EP-21-0084 Frindt Residence (Crystal Park Site S-124)

The applicant proposes a single-family residence at 5291 Neeper Valley Road in the Crystal Park development. With the original referral, we received the Site Plan (Haddon Architecture, April 14, 2021), Elevations (Hadden Architecture, April 14, 2021), and Soils Report (Geoquest, LLC, stamped November 3, 2020). The resubmittal documents include a Geologic Hazard Study (Rocky Mountain Group, March 17, 2021). RMG states, “Based on our evaluation of the geologic conditions, it is our professional opinion that the proposed residential development is feasible.”

Photo 1: Northern outcrop with detached rocks

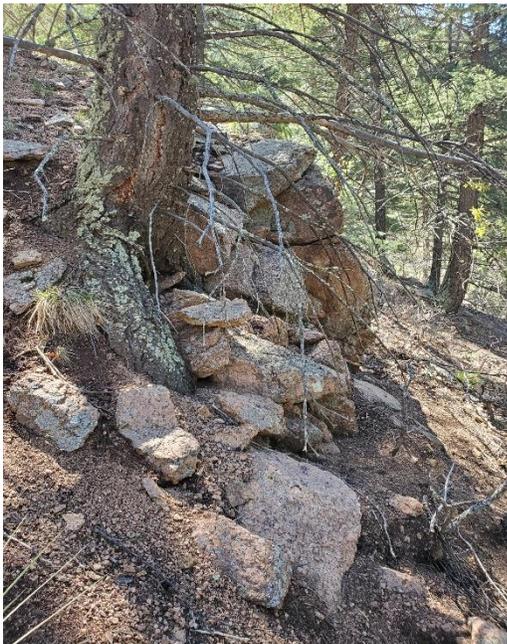
I visited the site on May 24, 2021. Site observations and available LiDAR show slopes ranging from 20 to 40 percent upslope and downslope from the proposed residence. While onsite, I did not observe signs of slope instability, such as soil creep or surface cracking. Two large outcrops are associated with the site. The outcrop on the northern portion of the site included some detached, precarious rocks (Photo 1). However, this outcrop is located approximately 65 feet to the north of the proposed building footprint and does not appear to be a risk to the proposed building. The outcrop to the east and upslope of the proposed structure includes some detached rocks; however, most are lichen-covered and partially embedded (see Photo 2). I also observed scattered rocks further upslope from this outcrop (Photo 3).

As previously stated, the bedrock at the site is the Pikes Peak Granite, forming outcrops directly upslope (to the east) and adjacent to the proposed building footprint (to the north) as well as scattered throughout the site. The existing rocks and boulders are likely to be disturbed during construction activities and/or freeze/thaw, resulting in an increased potential for a rockfall hazard. It may be prudent to remove such rocks during construction.

CGS continues to recommend the county require the risk for rockfall hazards be evaluated prior to construction and a mitigation plan established to reduce the potential risk. The appropriate mitigation measures should be noted on the project plans.
